Service Information Bulletin

SUBJECT	DATE
Aftertreatment Control Module (ACM)	May 2018

2 Inspection of the Aftertreatment Control Module

d140795

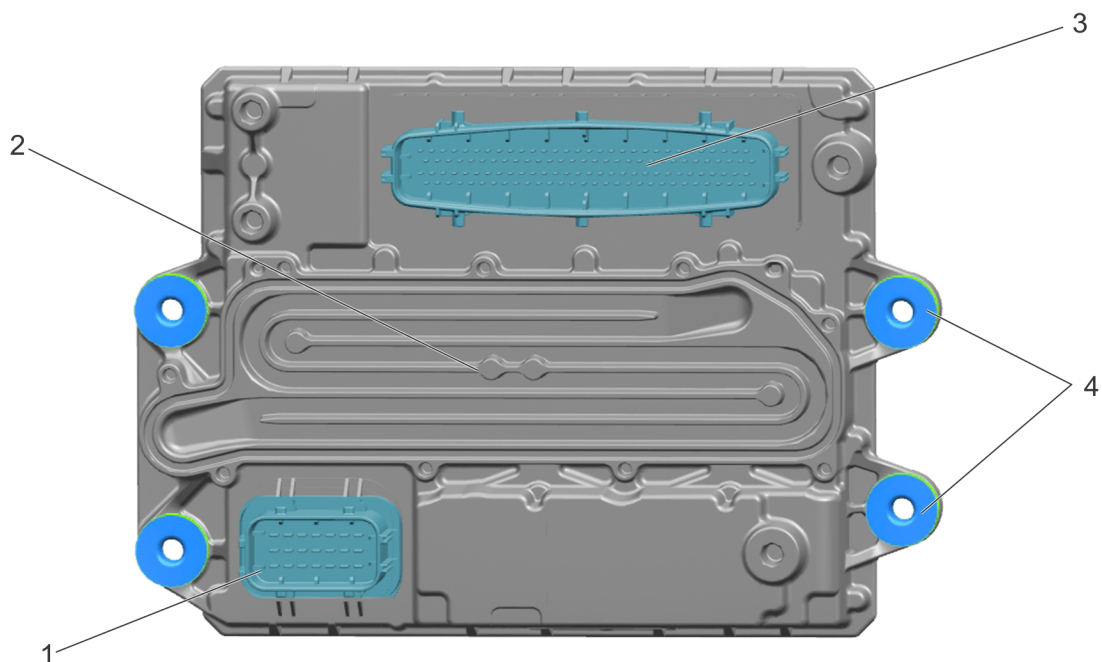
1. Inspect the 21-pin (1) and 120-pin (3) connectors on the Aftertreatment Control Module (ACM) for signs of moisture or water intrusion. If moisture or water intrusion is found, the associated harness should also be replaced.
2. Inspect the 21-pin (1) and 120-pin (3) connectors on the ACM for damaged or bent pins. Repair as necessary.
3. Ensure there is no physical damage to the ACM 21-pin (1) or 120-pin (3) or connector bodies. Replace the ACM as necessary.
4. Inspect the eight ACM isolators (4) for damage. Replace as necessary.
